Project: Cajon Valley Union School District

Bostonia Language Academy

Modular Classroom Buildings Relocation

Notice to Bidders:

Figure C: Walk-Off Mat

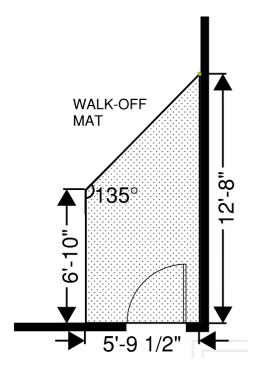
- 5. Remove existing flooring throughout and replace with carpet tile. Product to be 24"x24" Mannington Halftime Infinity Modular in Cobb color.
- 6. Provide walk-off mats at all exterior doors. Product to be Mannington Friction Force in Slide color 34368. See Figure C below for layout.

EF-01

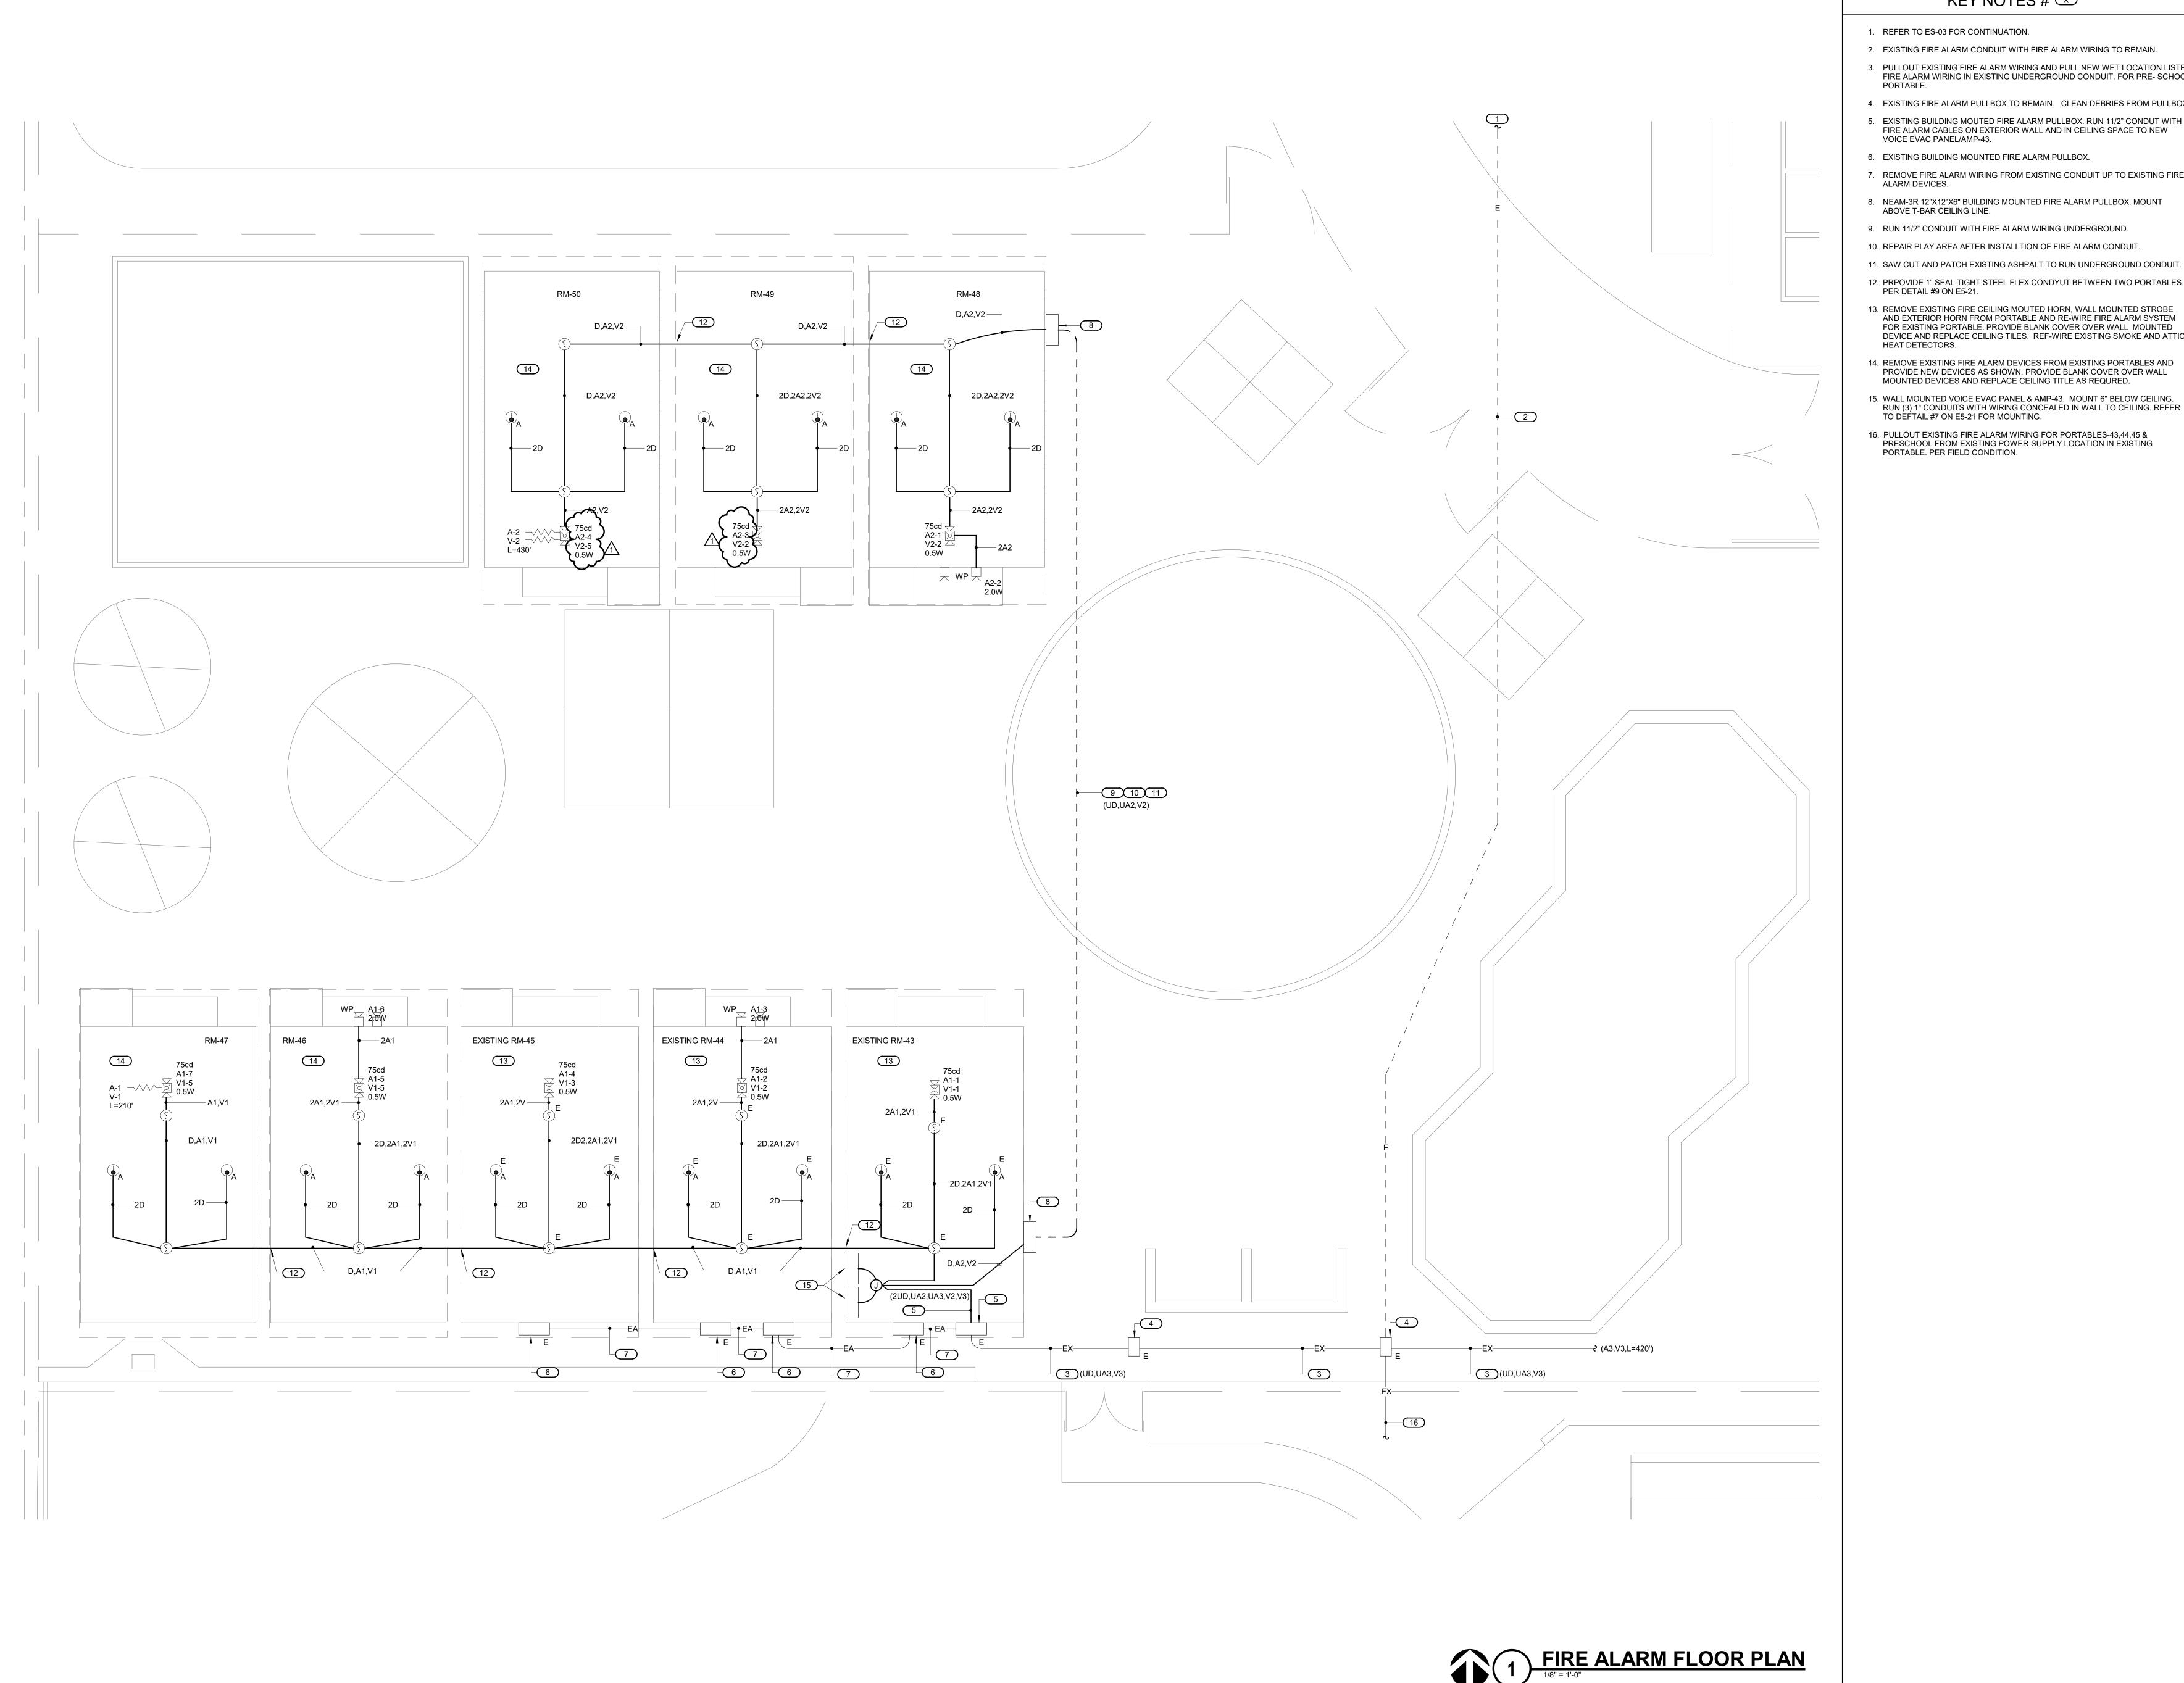
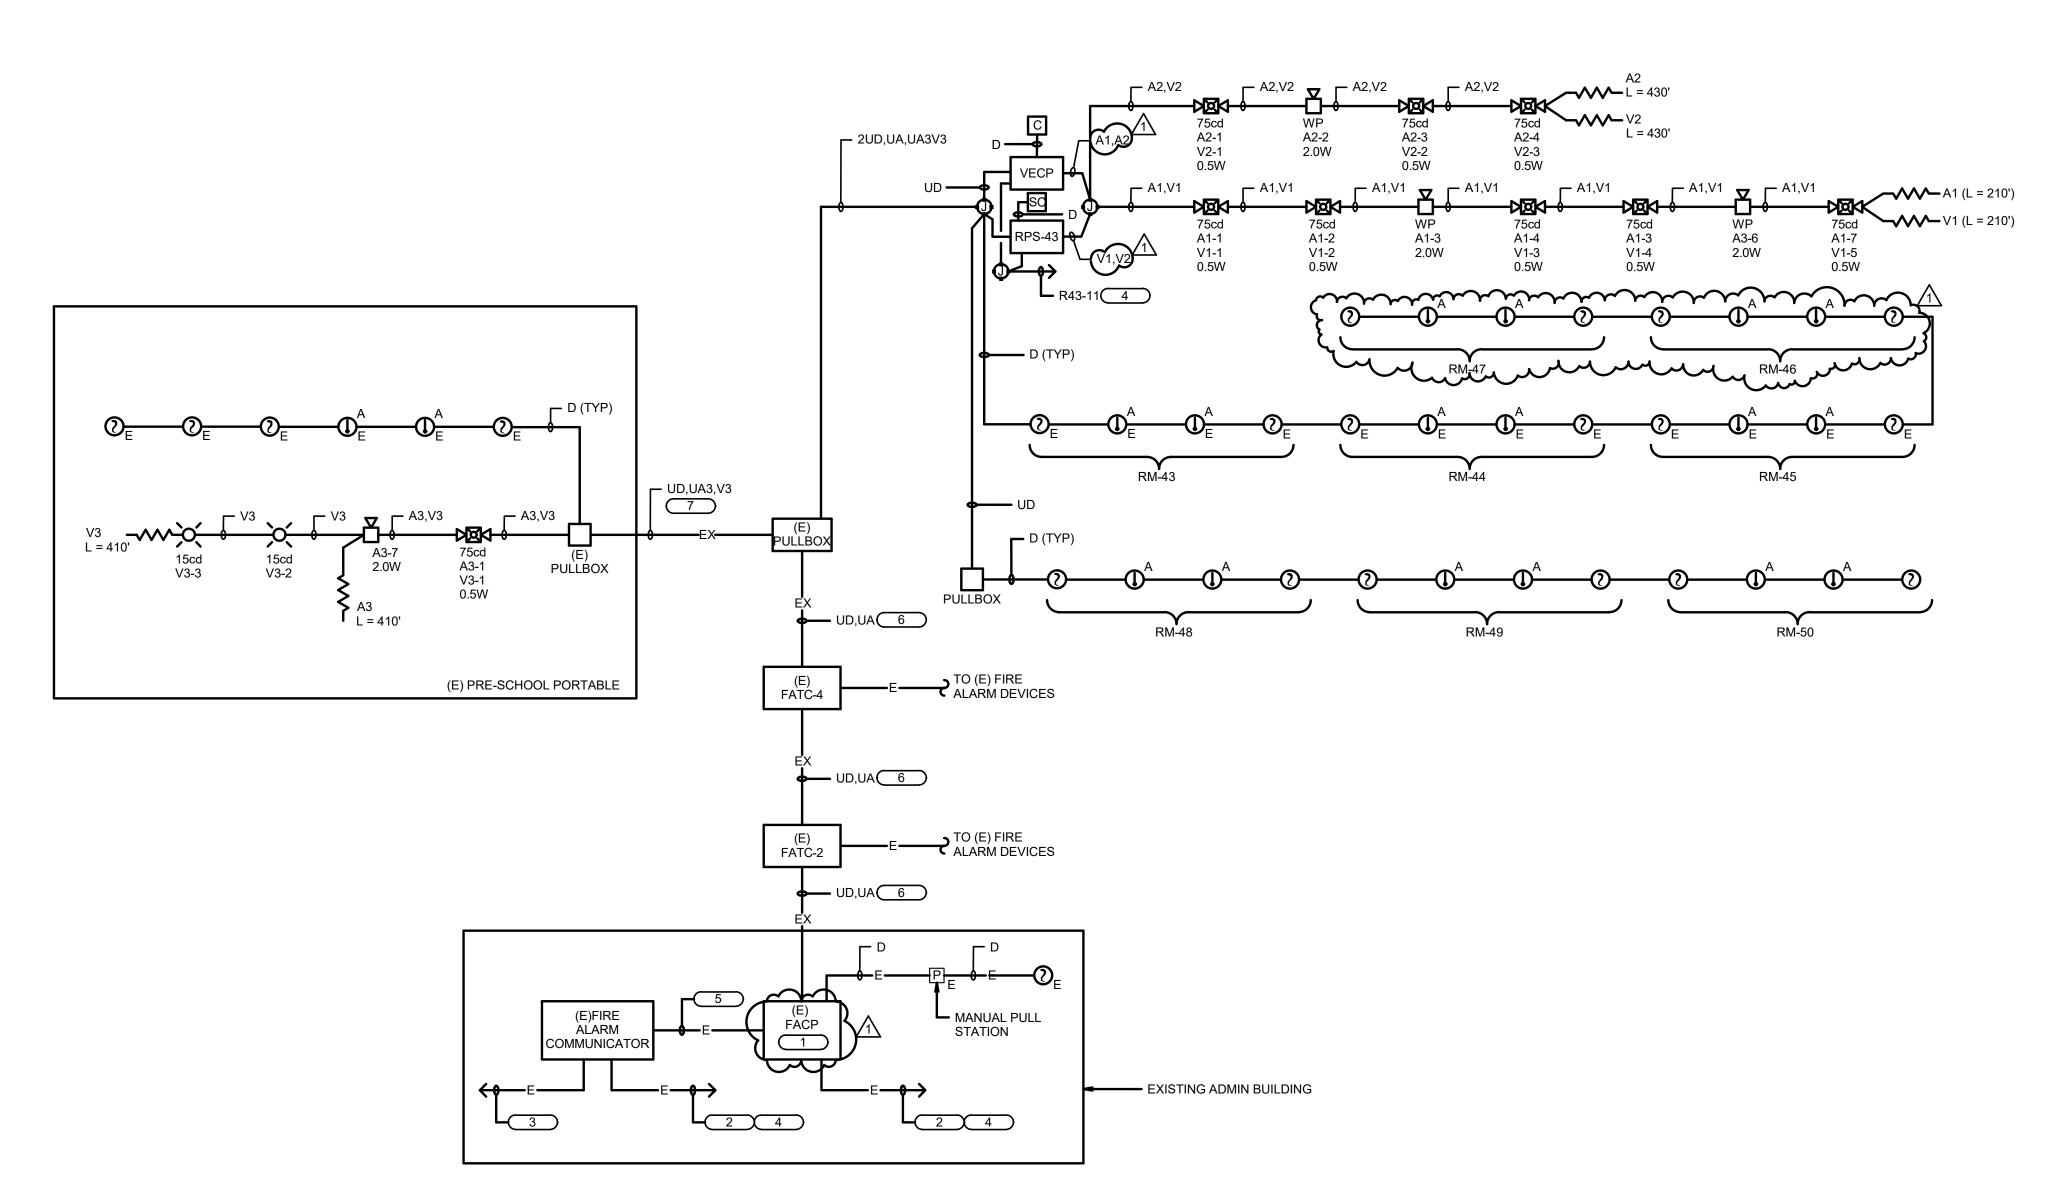
EF-01: Revised audio/visual circuit information in rooms 49 & 50.
